HISTORIC LANDMARK COMMISSION
Applications for Certificates of Appropriateness
November 4, 2026
HR-2026-130922
Hyde Park Historic District
4115 Avenue D

Replace non-historic windows on a contributing church structure.

Site visit photos, 2026. Windows have been replaced with fixtures that do not fit their openings.

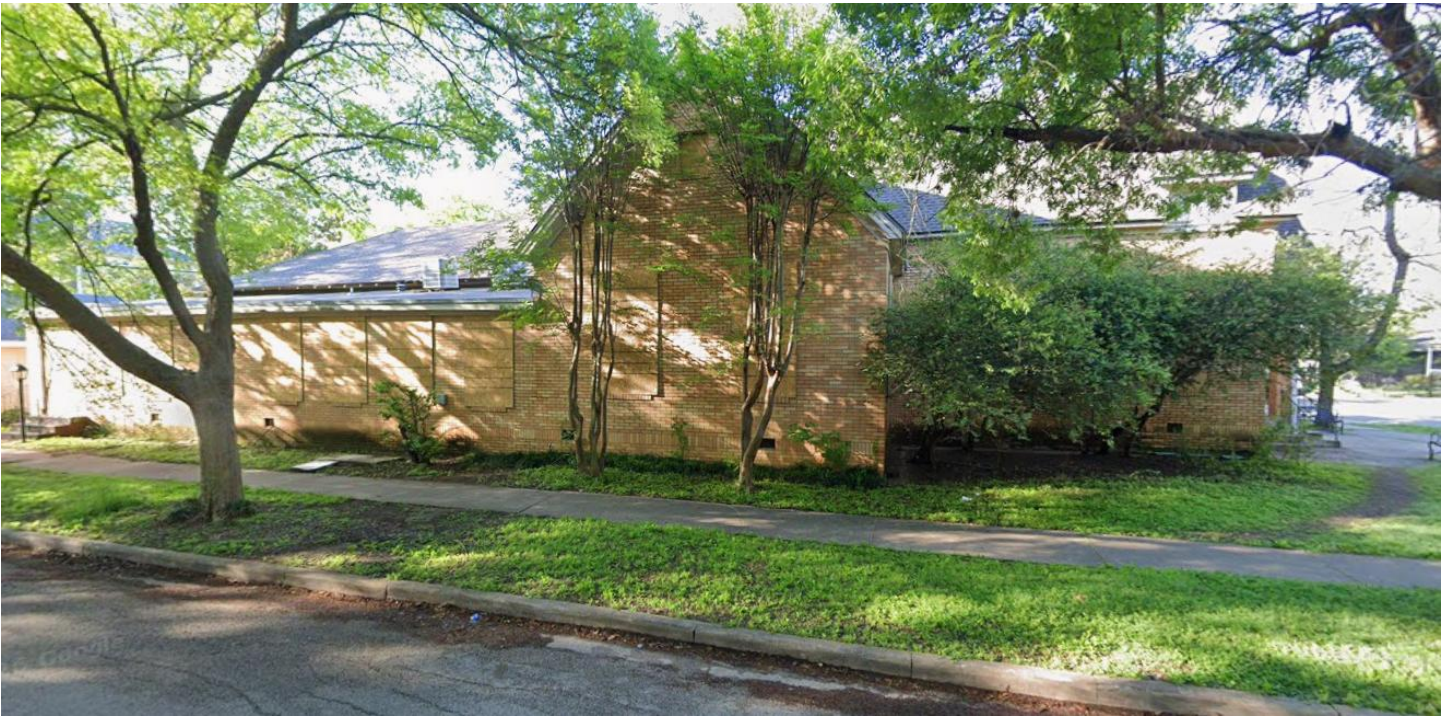
All windows on the church structure are proposed to be replaced. Prior to unpermitted work, the fixtures all appear to have been wood framed units, with 1-over-1s present at the front half of the building and 2-over-2s at the rear half, in the portion of the church that served as office space. These units were all lost during a previous owner's work and no physical evidence remains of them in the openings. Existing windows are white vinyl frame fixtures with false muntins and green tint. None of these windows are properly sized for their openings, and gaps have been filled with wood paneling painted black. This choice of color makes the size issue stand out even more visually, and greatly

Proposed windows are wood clad aluminum, and are sized appropriately to their respective openings. While wood hung windows that have a painted appearance would be ideal and highly recommended by staff, the proposed solution would be considered approvable for remediation of inappropriate work elsewhere in the district. Glazing appears to be clear and colorless, with a low-emissivity film serving as an alternative to tint.

Windows will need to be inspected to ensure that they fit properly and that no additional damage is done to historic material. Windows must also be located at an appropriate depth in their openings to ensure they do not look too deep or shallow. Past images of the original windows can be used as guidance for placement.

Approve the Certificate of Appropriateness in concurrence with Architectural Review Committee feedback. If any issues arise with proper sizing/fit of the windows into their openings, the applicant must contact the Historic Preservation Office to determine how to proceed.
